## Comments of the Association of American Railroads Before the PHMSA Hazardous Materials Enhanced Tank Car Standards and Operational Controls for High-Hazard Flammable Trains

#### DOCKET NO. PHMSA—2012—0082 (HM-251): HAZARDOUS MATERIALS: ENHANCED TANK CAR STANDARDS AND OPERATIONAL CONTROLS FOR HIGH-HAZARD FLAMMABLE TRAINS

# COMMENTS OF THE ASSOCIATION OF AMERICAN RAILROADS

Figure 4. Force-deflection curves for different tank outage volumes.

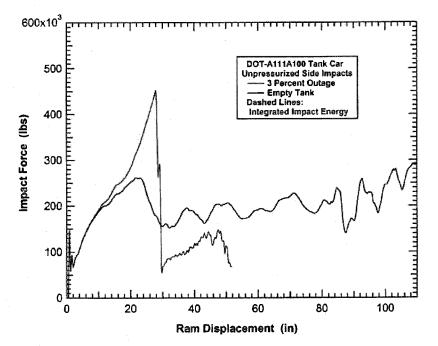
We believe that this approximation could have a significant influence on the calculated impact forces. In particular, the approximation could significantly under predict the impact forces for many impact conditions. Consider the comparison of two analyses with identical impact conditions shown in Figure 4 [9]. The identical tanks were impacted with a 6x6 inch impactor (286,000 lbs) at a speed of 16.2 mph corresponding to an initial 2.5 MJ impact energy from Reference. The tank in both analyses is a DOT 111 tank car design constructed with a 7/16-inchthick A516-70 steel tank shell. The only difference is that one of the tanks includes the effect of a 3% outage with the internal pressure calculated by a control volume that calculates the compression of the gas in the outage as the tank is dented and approaches a shell full condition. In the second analyses the tank remains unpressurized as if the tank were empty (although the weight of the lading was still smeared into the tank shell to maintain the inertial effects). This second analyses corresponds to the modeling approach used for the tanks in Reference 1.

In the first analysis (red curve), the impact forces begin to rise rapidly after approximately 20 inches of ram displacement to the point where the tank is punctured at a force of approximately 450 kips. With a larger impactor that did not puncture the tank, the forces would have continued to rise rapidly to significantly higher levels. The second impact response of the "empty tank", modeled without the lading compressibility effects, deforms the tank in excess of 100 inches without the impact force ever exceeding 300 kips (blue curve). Thus, not including the lading compressibility effect could significantly bias the analysis of the force distribution in Reference 1 toward a lower impact force distribution.

Figure 4. Average Percent Reduction in Energy Dissipated in the Derailment for ECP Compared to Other Braking Systems as a Function of Derailment Location within the Train

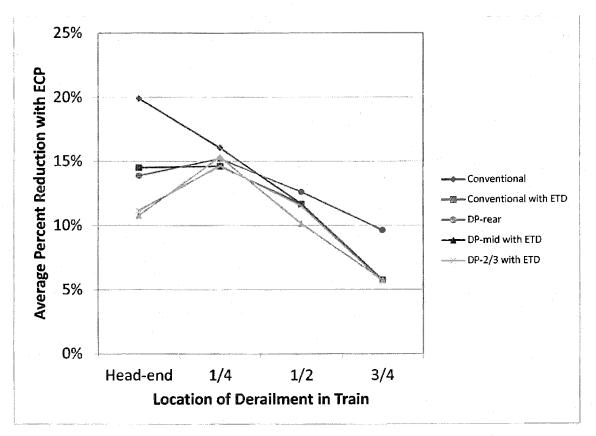
Figure 4 shows that the benefit of ECP relative to the other brake systems varies dramatically with where in the train the derailment occurs. In particular, the benefit of ECP relative to conventional (head end only) brakes is far better the closer to the head end of the train the derailment occurs. This illustrates the importance of considering derailments at various locations within the train in an analysis of the relative benefits of various brake systems.
